**Origination Form**  
Proposed Revisions to a Standard Plans Index

<b>Originator:</b>	Turley, Joshua	<b>Index Number:</b>	521-660
<b>Date:</b>	5/14/2024	<b>Sheet Number(s):</b>	2, 4
<b>E-mail:</b>	Joshua.Turley@dot.state.fl.us	<b>Index Title:</b>	LIGHT POLE PEDESTAL - BRIDGE

LAST REVISION 11/01/21	DESCRIPTION:	 FY 2024-25 STANDARD PLANS	LIGHT POLE PEDESTAL - BRIDGE	INDEX 521-660	SHEET 2 of 4
---------------------------	--------------	---	------------------------------	------------------	-----------------

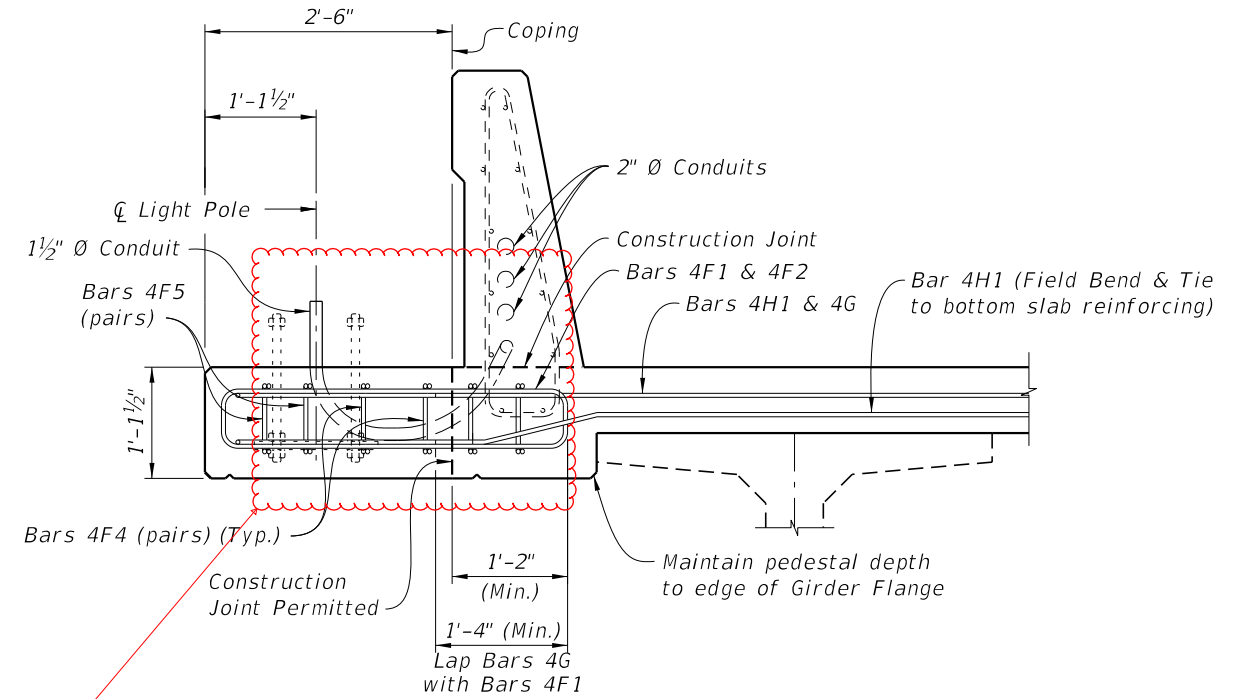
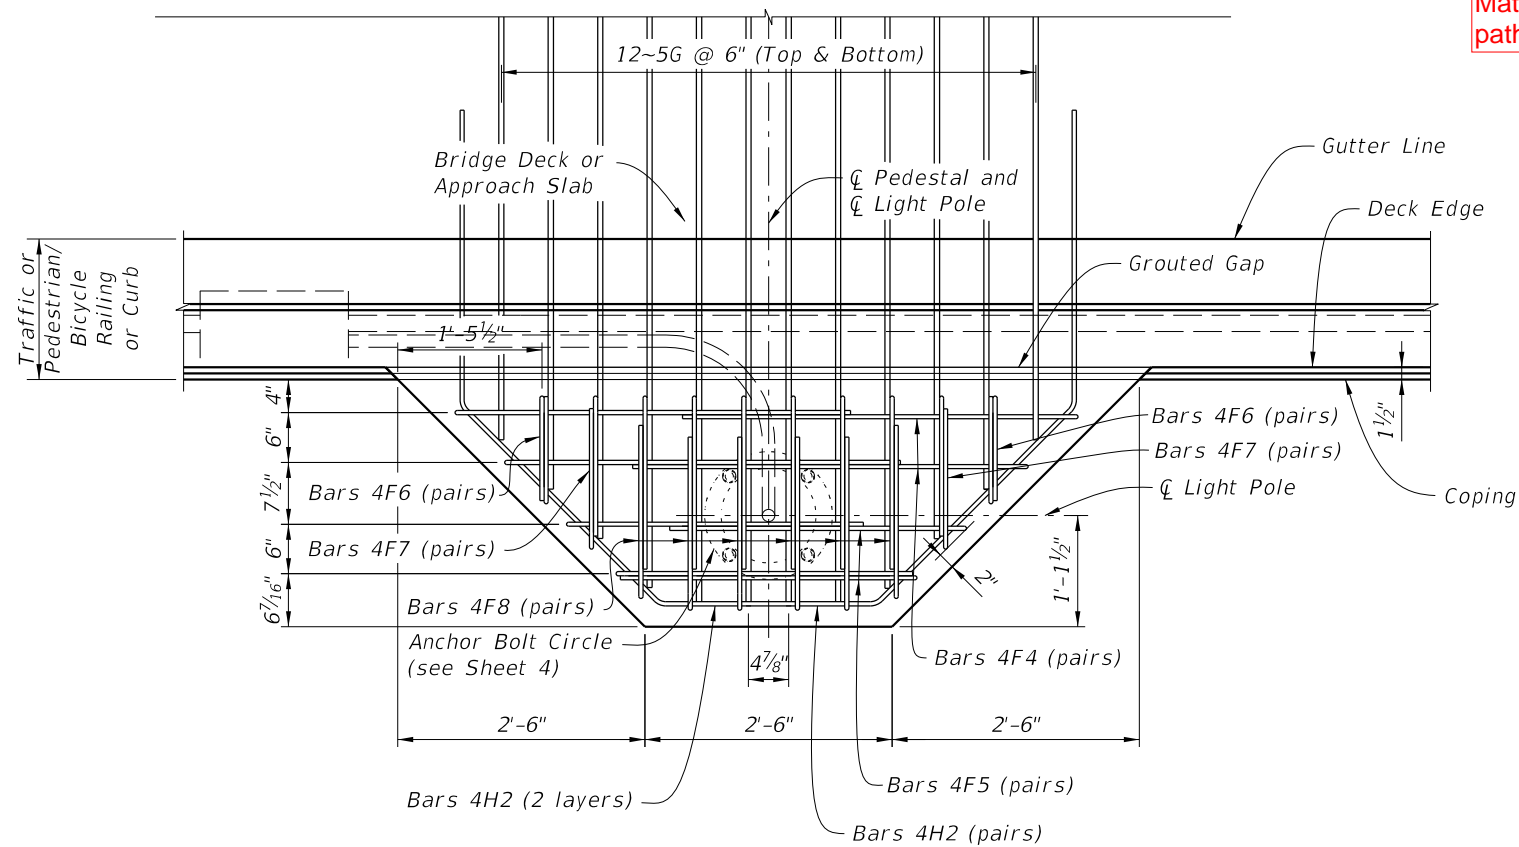
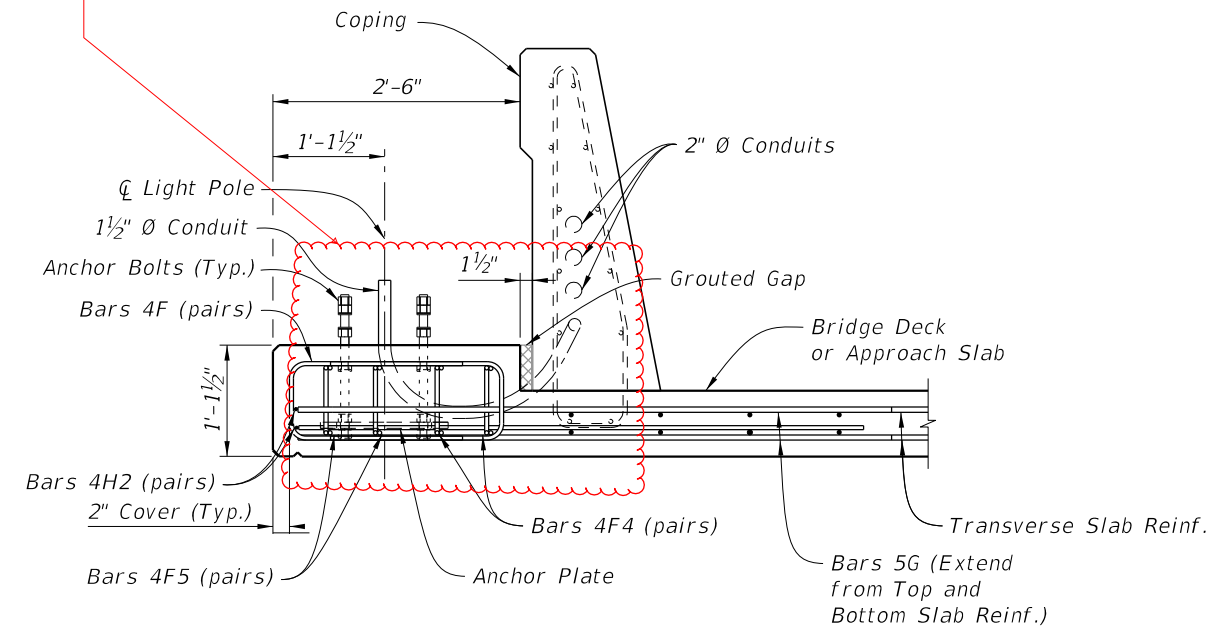
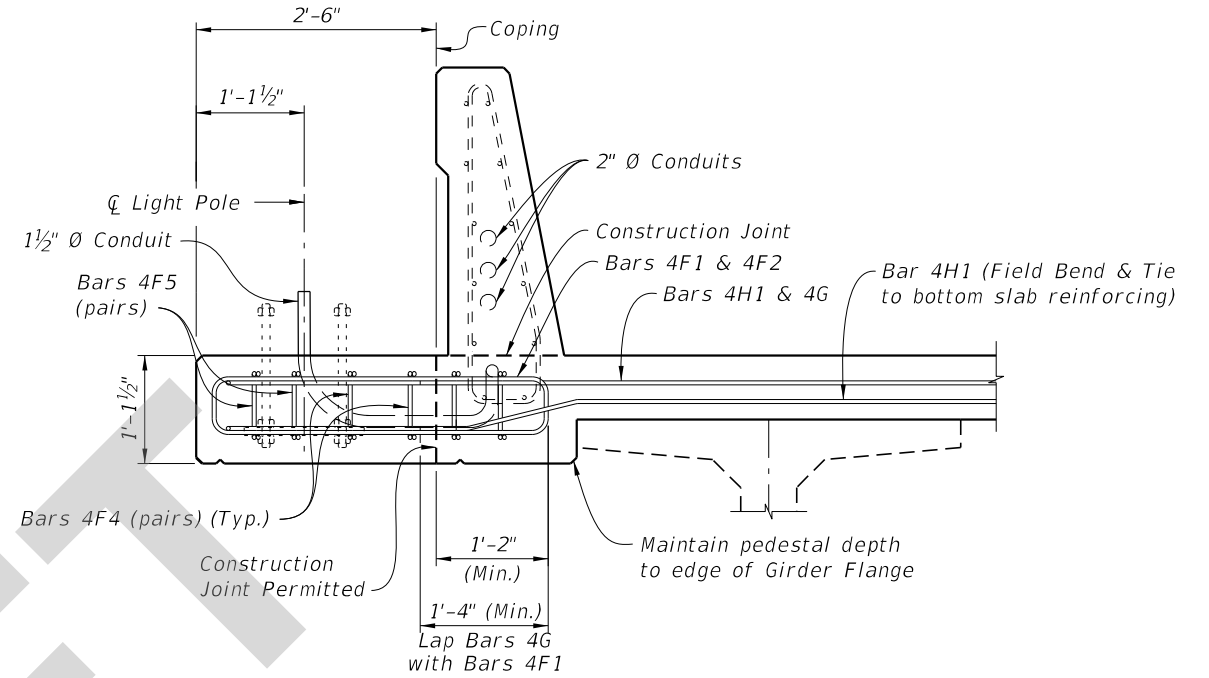
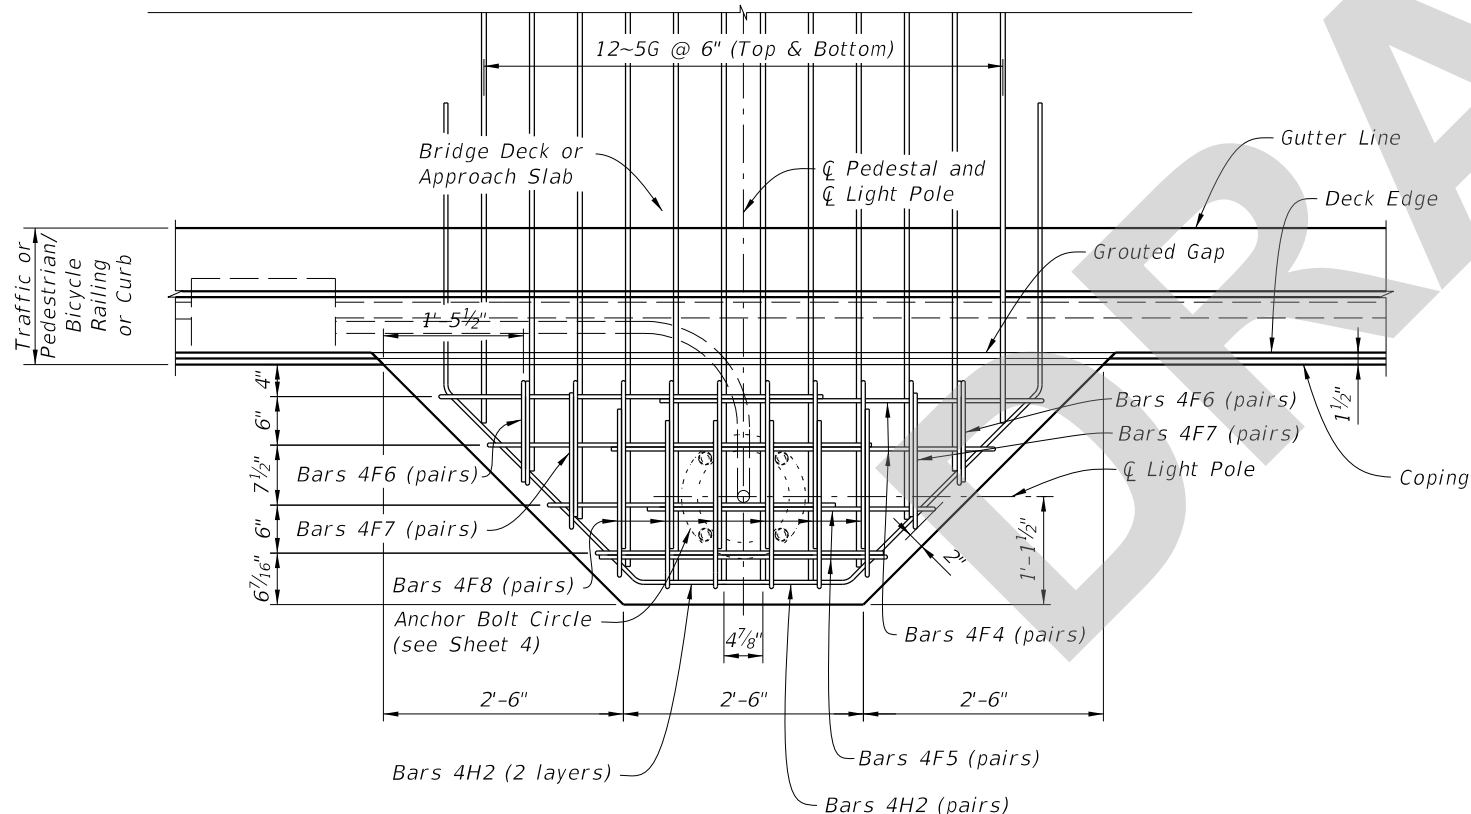
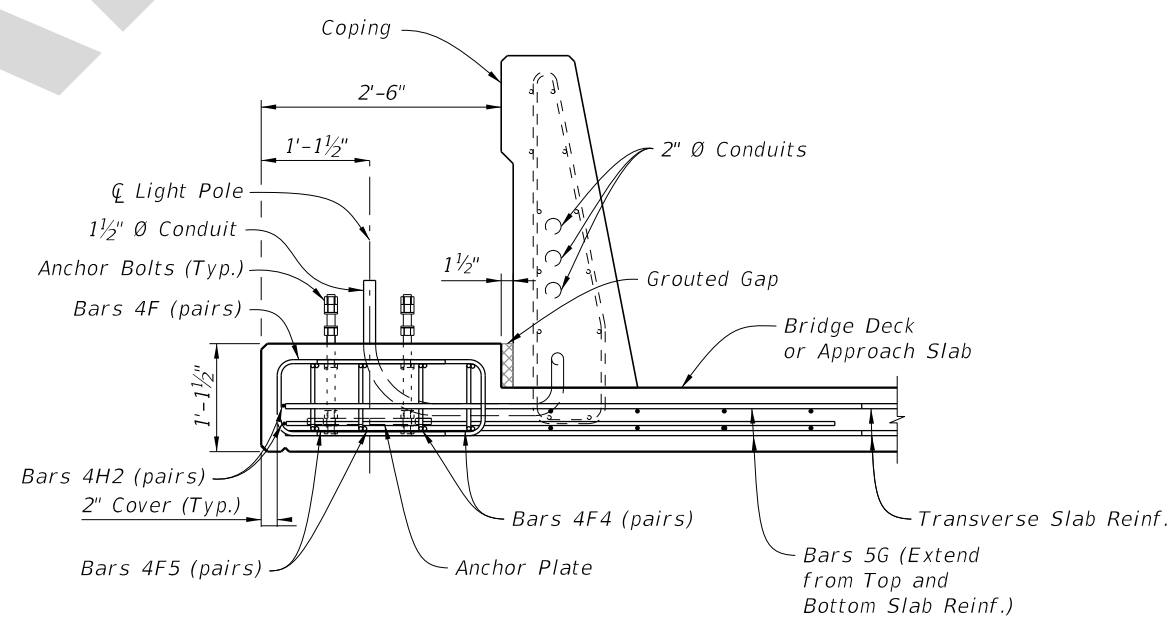
Sheet 2: Revised conduit path for the TYPICAL SECTION's.  
Sheet 4: Labeled the anchor bolt nuts in DETAIL "A"; Eliminated the anchor bolt table and updated corresponding notes.

Sheet 1: Conduit path was slightly incorrect so we fixed it.  
Sheet 4: We labeled the anchor bolt nuts to correspond with the Spec. We eliminated the anchor bolt table because it was from the ground application and gave the impression that all the configurations in the table were designed for for bridge mounted poles which was not the case.

Match the conduit curvature path of sheet 1 option 1.

LAST REVISION 11/01/24	DESCRIPTION:	 FY 2025-26 STANDARD PLANS	LIGHT POLE PEDESTAL - BRIDGE	INDEX 521-660	SHEET 2 of 4
---------------------------	--------------	---	------------------------------	------------------	-----------------

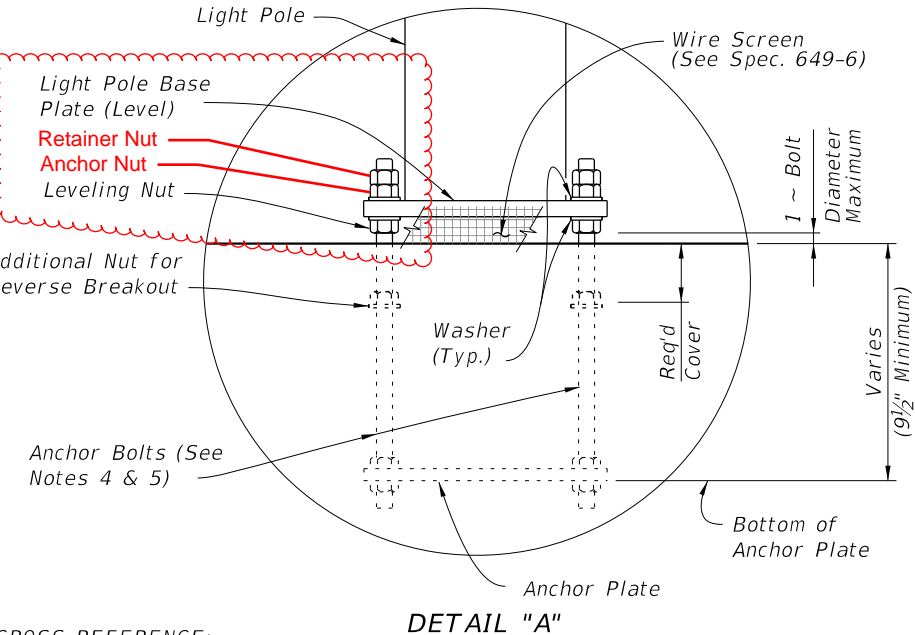
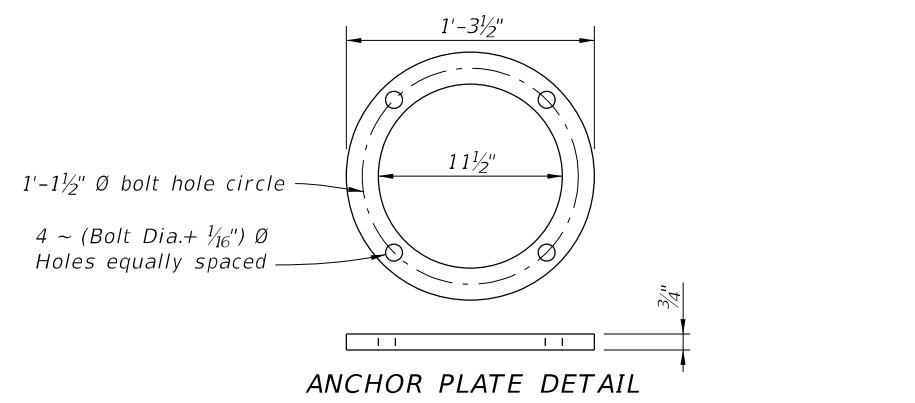
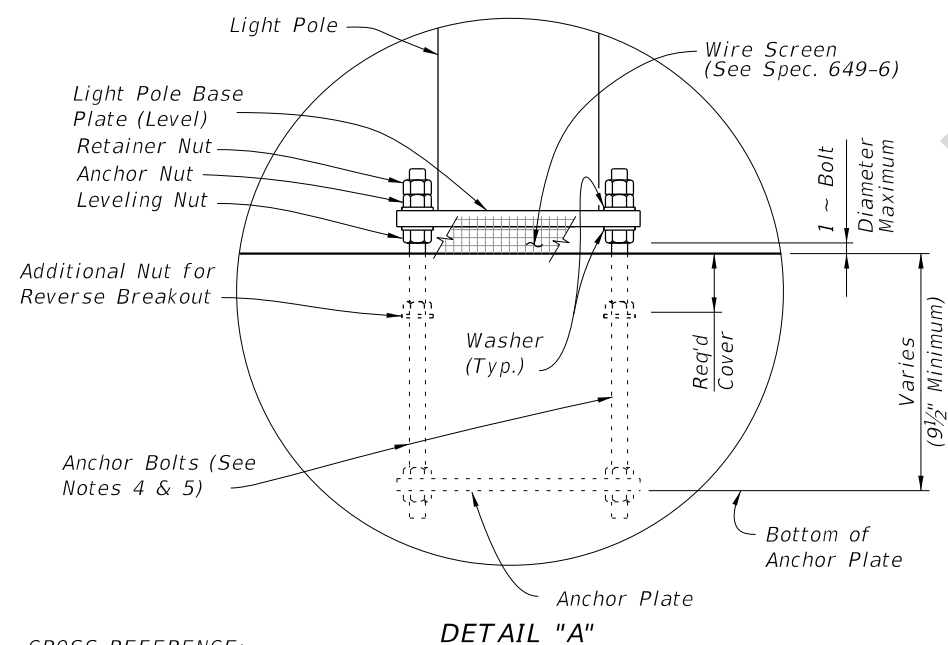
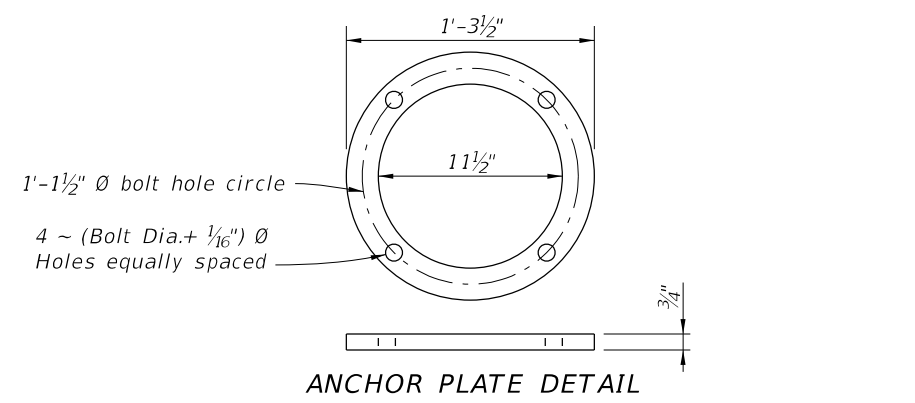
~~TABLE 1 - DESIGN LIMITATIONS FOR ANCHOR BOLTS (1" Dia.)~~

4. ANCHOR BOLTS:  
 Anchor Bolt design is based on the standard Roadway Aluminum Light Pole configurations shown on Index 715-002 with a maximum 40 ft. luminaire mounting height. Use 1" Ø anchor bolt for up to 75 ft. bridge deck height above natural ground or MLW.
